Interpretation Number: 1-11/09
Topic: Specifications of allowable inter packet gap values in IEEE 802.3
Relevant Clause: Clause 4
Classification: Request for Interpretation

Interpretation Request

Topic: Specifications of allowable inter packet gap values in IEEE 802.3

Interpretation for Specifications of allowable inter packet gap values in IEEE 802.3

Figure 1: Basic network scenario and LAN CSMA/CD layer structure including repeater set reference model of Gigabit Ethernet (1000-Mb/s operation)

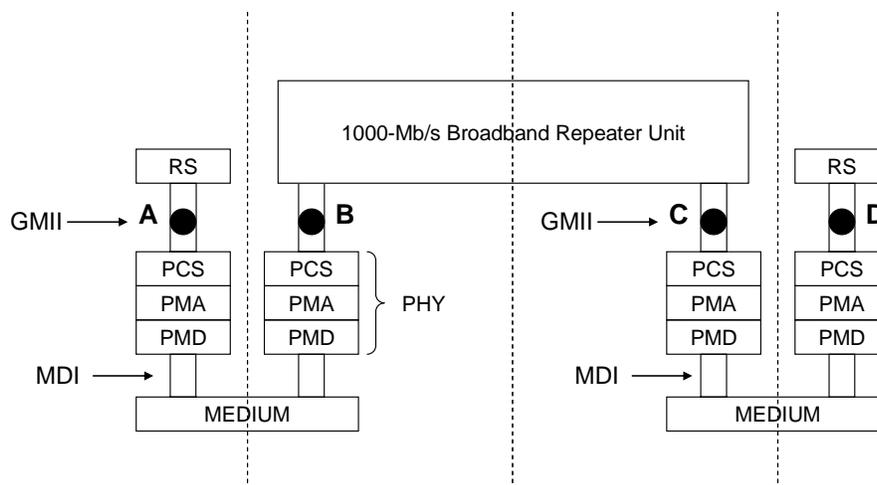
At which point is the allowable IPG value (96 bits) in the table of 4.4.2 specified? (GMII in GbE case?) Figure 1 shows a basic network scenario and LAN CSMA/CD layer structure that includes a 1000-Mb/s repeater unit. According to Note3 below the table in 4.4.2, IPG values

seem to be regulated at GMII at the DTE. Point A seems to be applicable; however, points B, C, and D do not seem to be applicable. There do not seem to be clear descriptions in the main body

of 4.4.2 regarding at which point the values are regulated.

The standard is unambiguous. Sub clause 4.4.2, Table 4-2, defines the value of the constant 'interPacketGap' for the various MAC data rates. As stated in sub clause 4.2.7.2 'Transmit state variables' the constant 'interPacketGap' defines the 'minimum gap between packets'. Sub clause 4.2.8 'Frame transmission' in 'process Deference' uses the constant 'interPacketGap' in full duplex operation, and the constants 'interPacketGapPart1' and 'interPacketGapPart2' derived from the constant 'interPacketGap', in half duplex, to control the minimum transmit gap between packets from the MAC. The use of the constant 'interPacketGap' to control the minimum gap between packets is further described in sub clause 4.2.3.2.1 'Deference'.

The 96 bit value defined in sub clause 4.4.2 therefore applies at MAC transmit, which is defined at the PLS service Interface. In the specific case of 1Gb/s MAC data rate, since the Reconciliation Sublayer (RS) does not define any allowed change in the value of the Inter-Packet Gap this value also applies at the GMII in the transmit direction. Note that this is not necessarily true for all other MAC data rates.

Figure 2: One example of GbE connection through OTN including GFP-T section

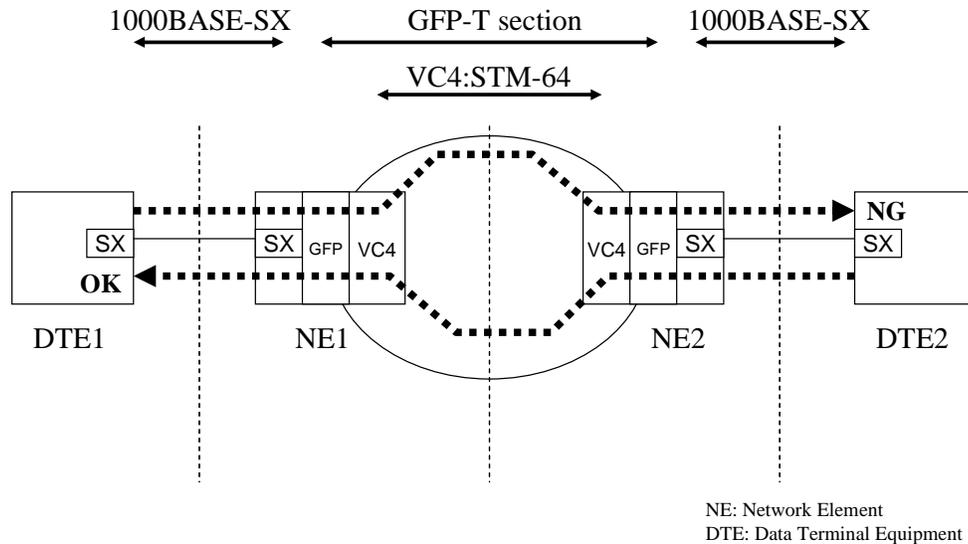
First, we need to consider IPG shrinkage in 2-byte units. We would like to consider the rate adaptation process specified in G.7041. If there is frequency deviation between the output signal from DTE1 and input signal to DTE2, rate adaptation needs to be applied. Then, NE1 and NE2 can be regarded as repeater, and the maximum frequency deviation is 200 ppm, according to Table 38–3 in IEEE 802.3. For example, when the output signal from DTE1 is +100 ppm and the input signal from DTE2 is –100 ppm, the IPGs have to be removed using rate adaptation. The client-specific rate adaptation is specified in section 8.4.1.2.4 in G.7041. The minimum unit that can be removed from a GbE signal is /I2/, which is one of the 2-byte order sets. Therefore, if the frequency offset of the DTE1 output signal is larger than that of the DTE2 input signal, a 2-byte Idle removal has to be done for rate adaptation at certain intervals.

For example, assuming that relative frequency deviation between input and output signals is +200 ppm, that is, when the output signal from DTE1 is +100 ppm and the input signal from DTE2 is –100 ppm, if the packet size is 1518 bytes with a continuous 12-byte IPG interval, the probability of a 2-byte IPG shrinkage per one frame cycle (=1538 bytes) will be about 15% (= (1518: data+8: preamble+12: IPG) bytes * 200 ppm / 2 bytes / 100). This means that the size of an IPG in a GbE signal can change from 12 to 10 bytes at certain intervals. The actual size of the IPG seems to show some distribution because of clock tolerance. The point here is that IPG shrinkage could happen in 2-byte units for rate adaptation irrespective of the size of the frequency difference if there is a frequency deviation.

Second, we need to further consider the IPG shrinkage by 8-bit. According to the description in section 41.2.1.3.2 and B.1.5.3, a repeater set seems to be able to remove IPG because of “Preamble

regeneration”. This might happen at point C in Fig. 1. Therefore, additional removal of 8-bit IPG seems to be able to be designed in the GFP-T section.

It is estimated that the 24-bit IPG might be removed when the two above cases of shrinkage are simultaneously applied in the intermediate NEs. Moreover, there is no description about the 8-bit guard band in the formal IEEE 802.3 standardization, it is also estimated that the total 32-bit IPG might be removed. If the receiver side can not receive a GbE signal correctly, it leads to packet losses. Therefore, we need to design or guarantee the allowable IPG size at NEs.

We tested the network scenario in Fig. 2 in our laboratory; GbE traffic was sent from DTE1 to DTE2 and also from DTE2 to DTE1. As a result, packet loss was detected once per few minutes in the direction of DTE1 to DTE2 and not in DTE2 to DTE1. The traffic rate was 990 Mbps in which IPv4 (64, 256, 1518 bytes): 495 Mbps and IPv6 (82, 256, 1518 bytes): 495 Mbps were mixed. In this case, the received IPGs at the DTE2 can be minimum 64-bit, because the NE2 can send 64-bit IPGs to the DTE2, following the Note3 of table in section 4.4.2 of IEEE 802.3.
